IDAP REPORT

Property:	16 Wentworth Street, Greenacre Lot 3 DP 36122 DA2021.103
Proposal:	Construction of 2 swimming pools, 2 garden storage rooms and alterations to the driveway and terraces.
Applicant:	ZTA Group
Owner:	Zakariah Abdul Rahman
Date of lodgement:	26 May 2021
Notification period:	02 June 2021 to 16 June 2021
Submissions received:	One
Assessment officer:	P Santos
Estimated cost of works:	\$60,073.00
Zoning:	R2 - Low Density Residential - SLEP 2012
Flood affected:	Yes
RECOMMENDATION OF OFFICER:	REFUSAL

Figure 2. Extract of the proposed site plan, drawing # A100, issue C, dated 01/07/2021.

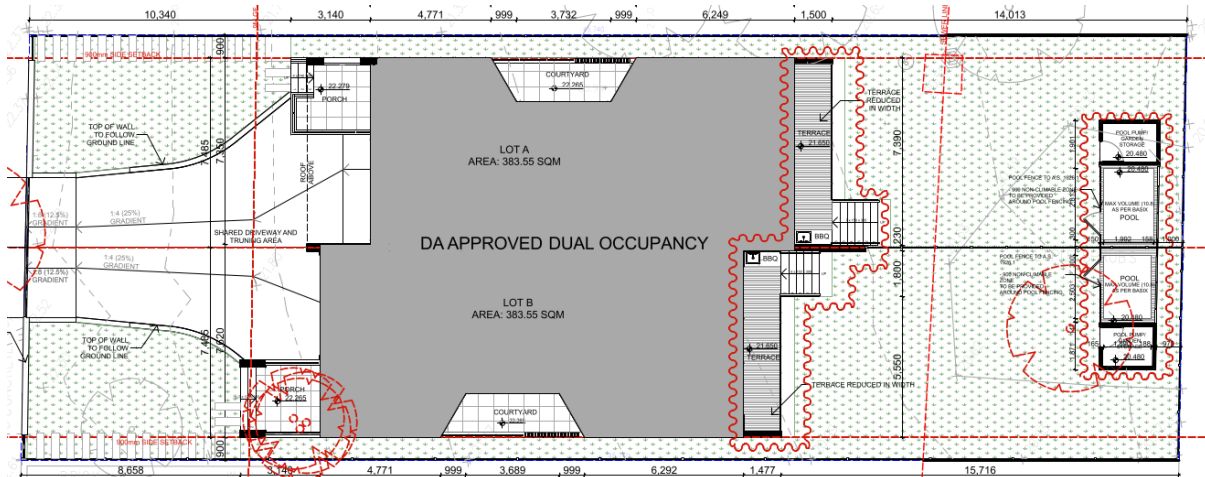
The SCDGP 2005 requires a landscaping of 40% (306.84m²). Notwithstanding the issue with the inconsistent pavers installed within the frontage, the current proposal does not satisfy Council's landscaping requirements for a site occupied by a dual occupancy development. The proposed landscaping is 38.76% (297.4m²), which presents a shortfall of 9.44m².

Note that the site is flood affected and hence, the area that is landscaped should be maximised to provide pervious area for the flood water in the event of flooding.

Figure 3. Extract of the initial proposed site plan, drawing #A100, issue B, dated 10 May 2021.

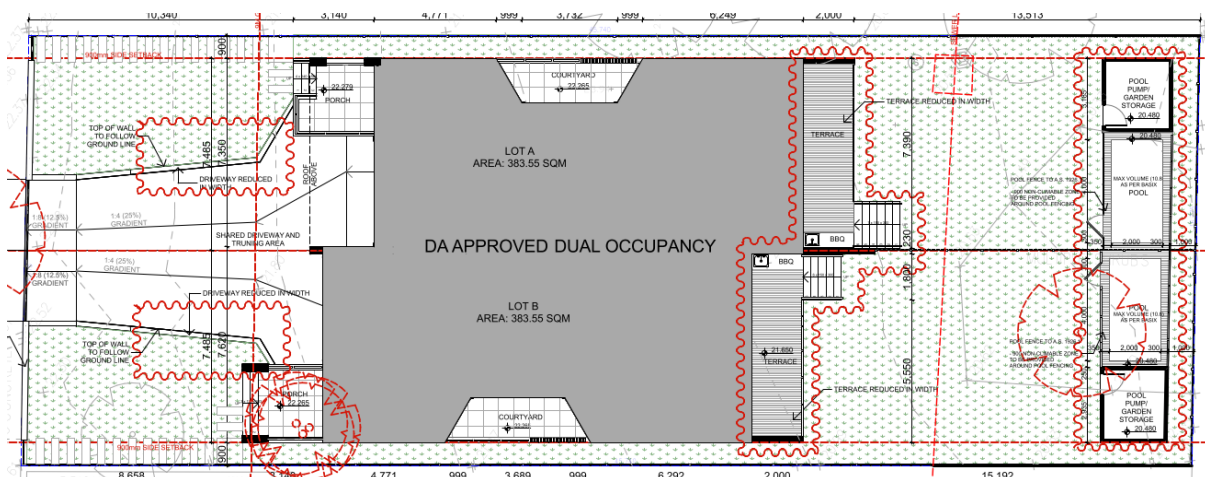
The application was referred to Council's Traffic Manager who offered objection to the initial driveway design as shown in Figure 3. In particular, Council's Traffic Manager provided the following comment –

"The basement and the associated driveway must be reverted to the original design as approved under DA2019/198/2 to enable adequate vehicle manoeuvring."

Note that initially, the application involved an alteration to the driveway to a more narrow design as shown in Figure 3 below. This was the design the applicant provided in DA2019/198 when turntables were proposed in the basement of each dwelling. The narrow driveway and turntables were requested to be removed and the driveway approved in DA2019/198/2 reinstated. For completeness, the driveway was redesigned back to the approved driveway in the most recent modification application (DA2019/198/2) and does not form part of the current proposal anymore.

Figure 4. Aerial imagery of the site captured on 6/08/2021.

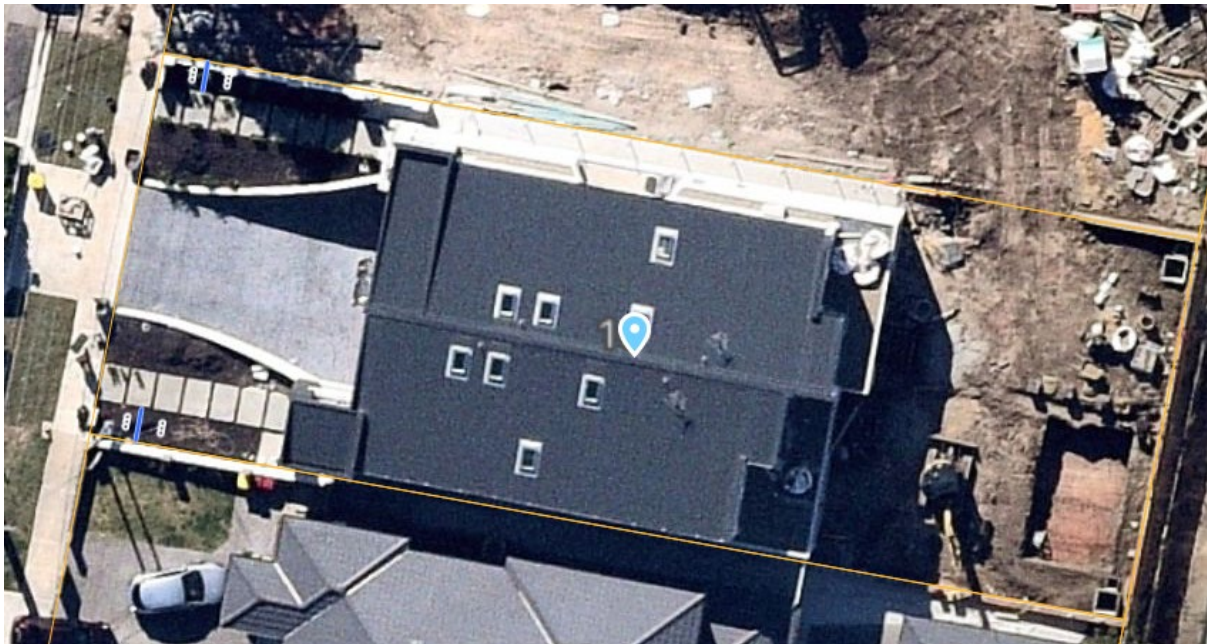
The aerial imagery shown in Figure 4 below and Council's most recent site visit triggered the referral of the application to Council's Compliance Officer. Based on the imagery, works were undertaken without Council's consent (i.e. swimming pool excavation) and some structures were placed and resulted to inconsistency to the proposal (i.e. pavers claiming to be landscaping on the plans).

While it appears that the variation is minimal, it can be noted that the pavers installed within the frontage as revealed in Council's site visit and Figure 4 have bigger dimensions and smaller gaps in-between resulting to a greater built-upon area as oppose to what has been demonstrated on the most recent set of plans provided to Council. Figure 5 below. Note that an opportunity was provided to the applicant to provide amended plans showing the currently installed pavers.

Figure 5. Extract of the Landscape Plan, drawing #LP100, received by Council on 26/08/2021 via the NSW Planning Portal.

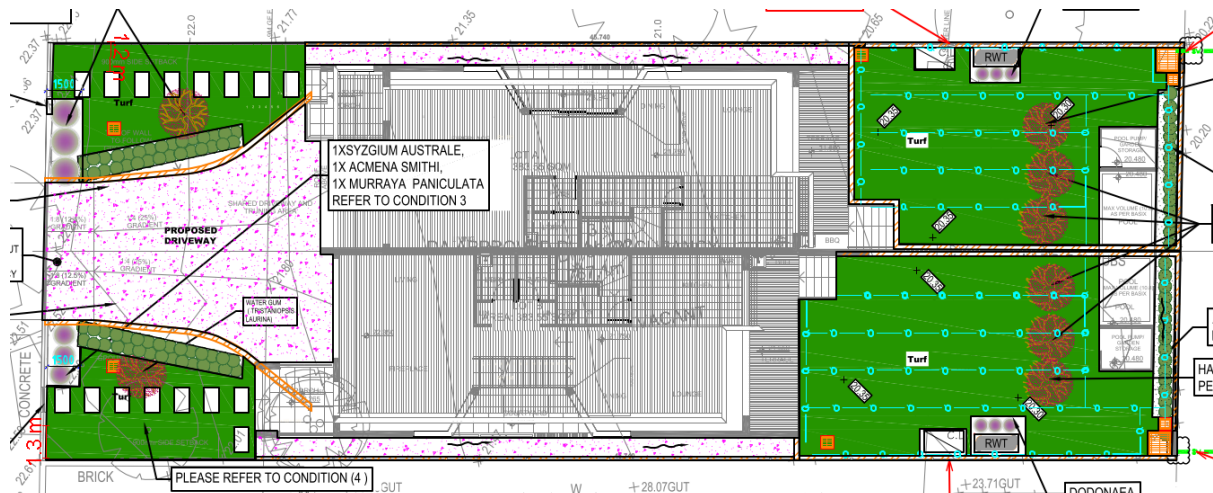
As a result of the above, Council cannot assess the built-upon area due to inadequate information provided. Further, this matter will be referred to Council's Compliance Team to ensure that no breach of development consent DA2019/198/2 has been undertaken.
